## DEPARTMENT OF TRANSPORTATION

RE: Preliminary Plan No. 120250040  
PLD Lot 25 Redevelopment  
Preliminary Plan Letter

We have completed our review of the revised preliminary plan uploaded to eplans on January 17, 2025. A previous version of the plans was reviewed by the Development Review Committee at its October 22, 2024, meeting. This plan is tentatively scheduled for the March 27, 2025, Planning Board meeting. We recommend approval of the plans subject to the following comments:

PLD LOT 25  
REDEVELOPMENT  
820250030  
FIRE ACCESS PLAN

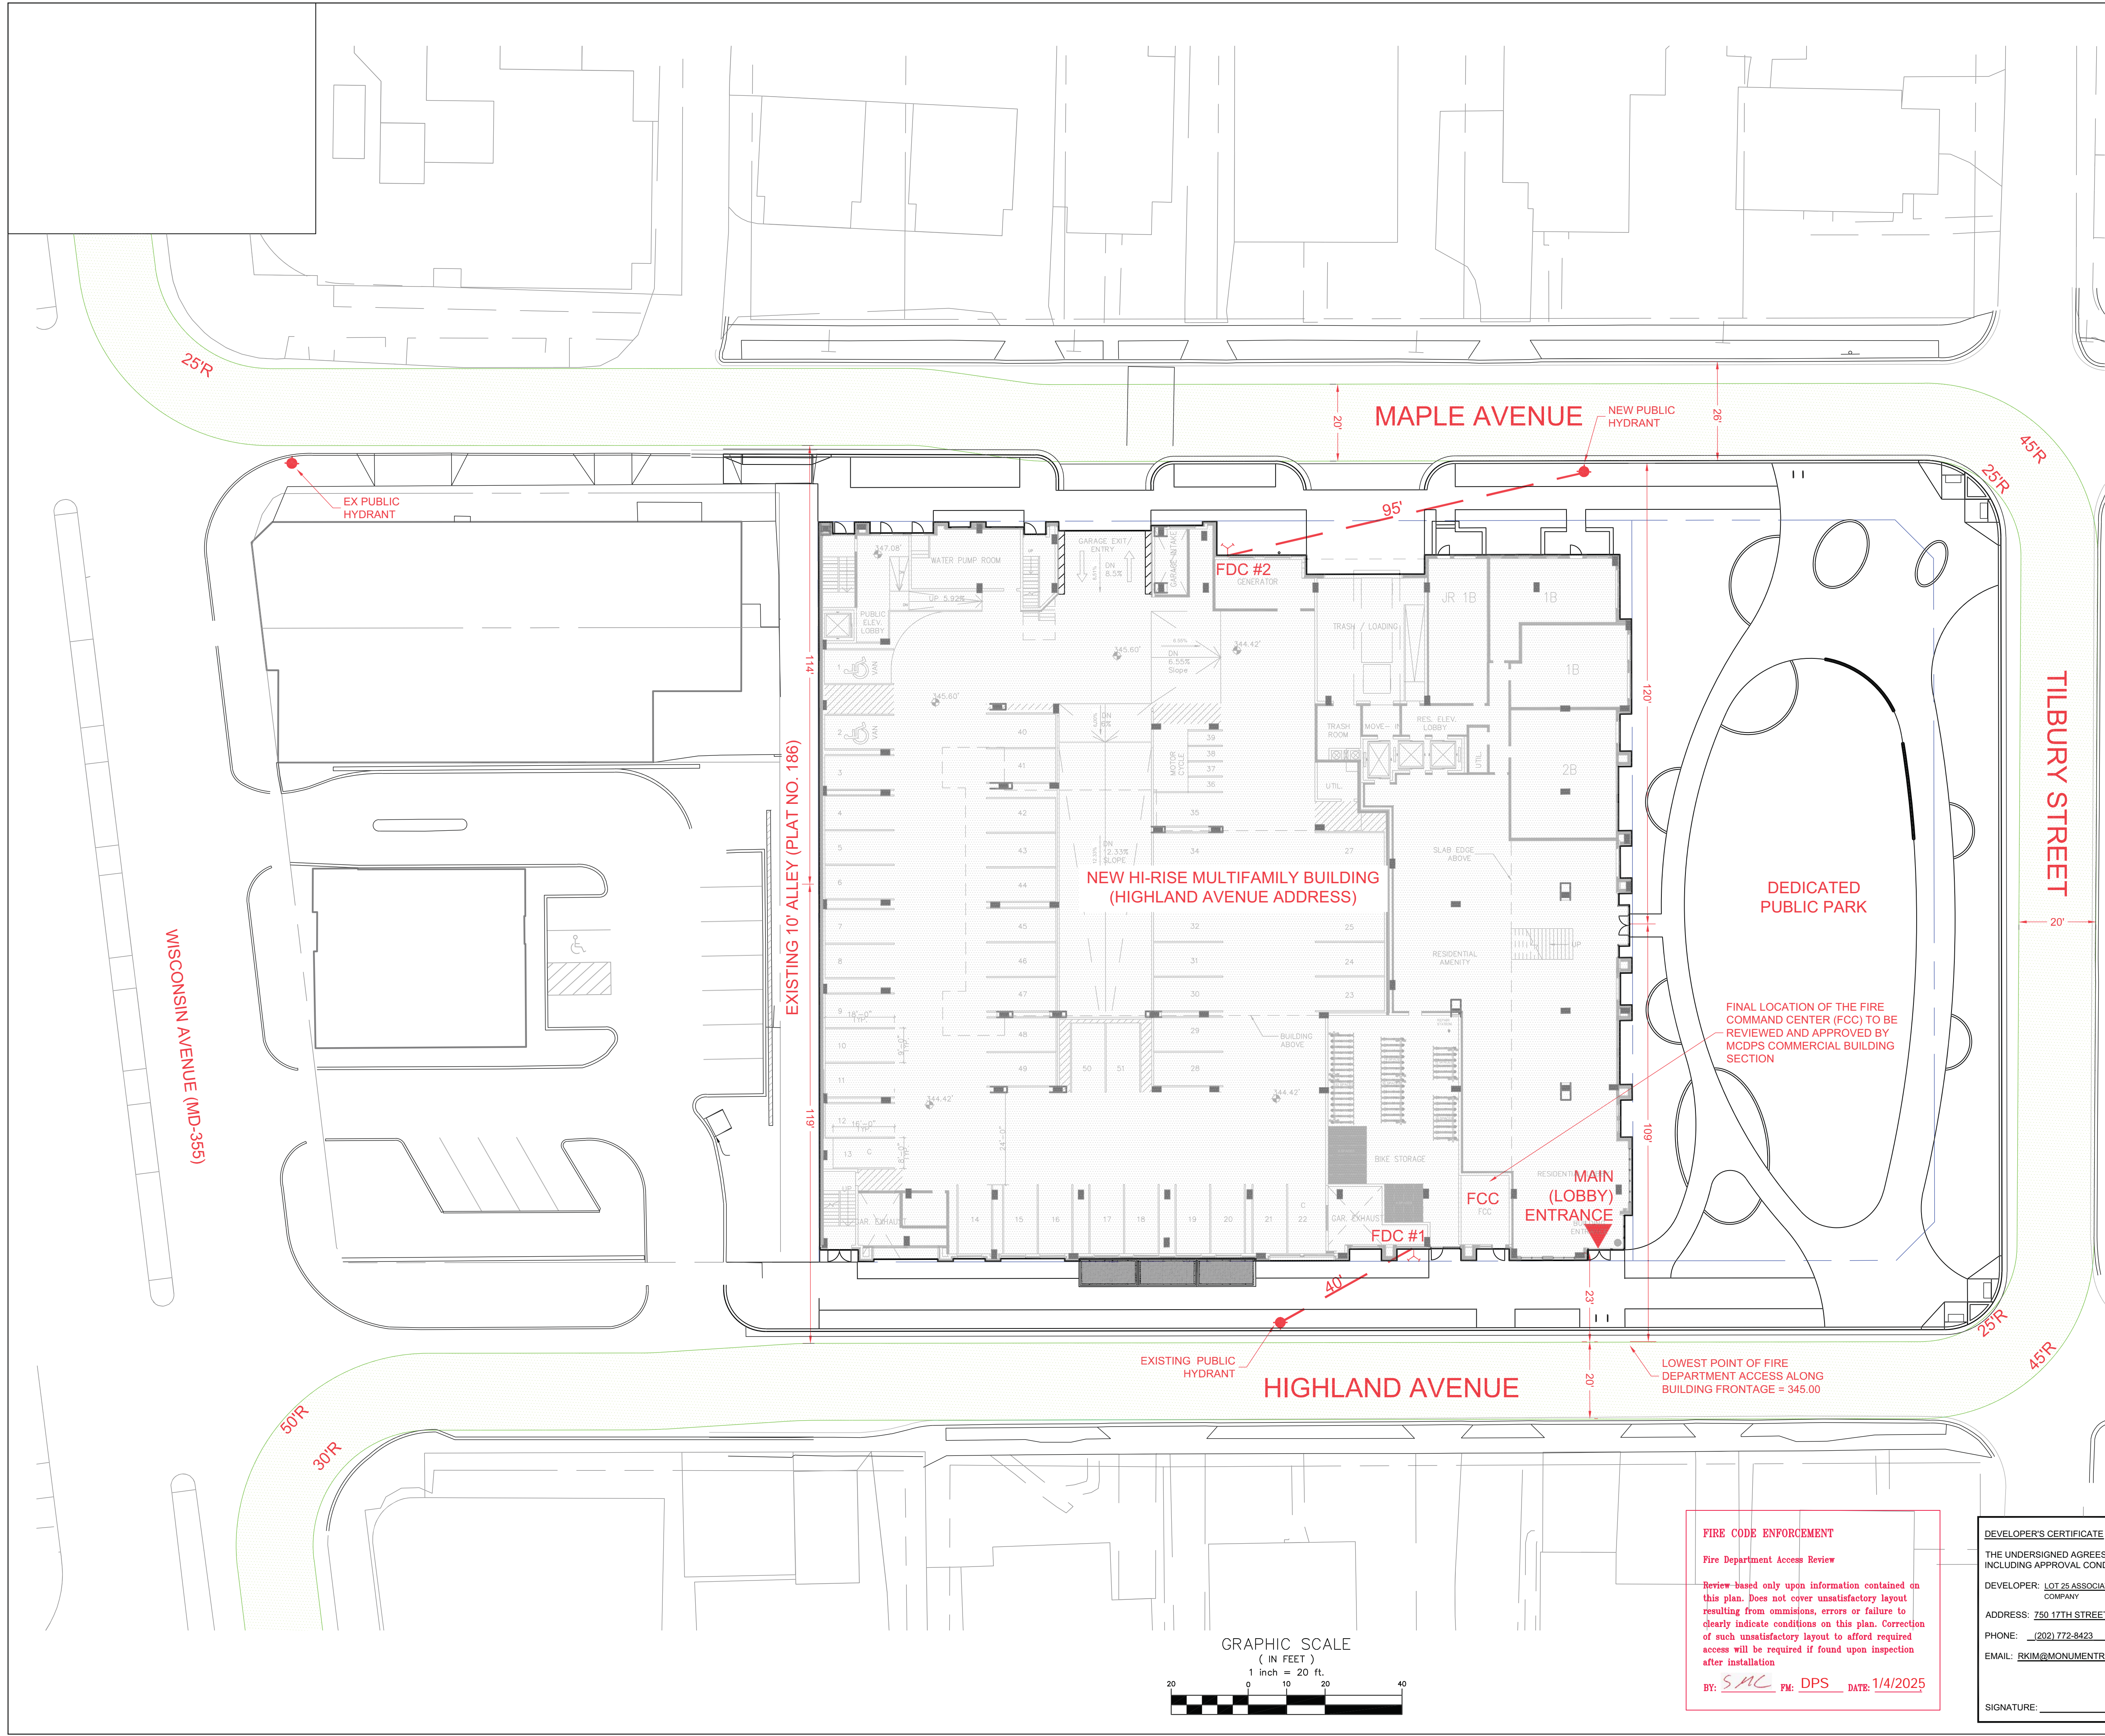
**PLAN APPROVED**

1. Review based only upon information contained on the plan submitted **30-Dec-24**. Review and approval does not cover unsatisfactory installation resulting from errors, omissions, or failure to clearly indicate conditions on this plan.
2. Correction of unsatisfactory installation will be required upon inspection and service of notice of violation to a party responsible for the property.
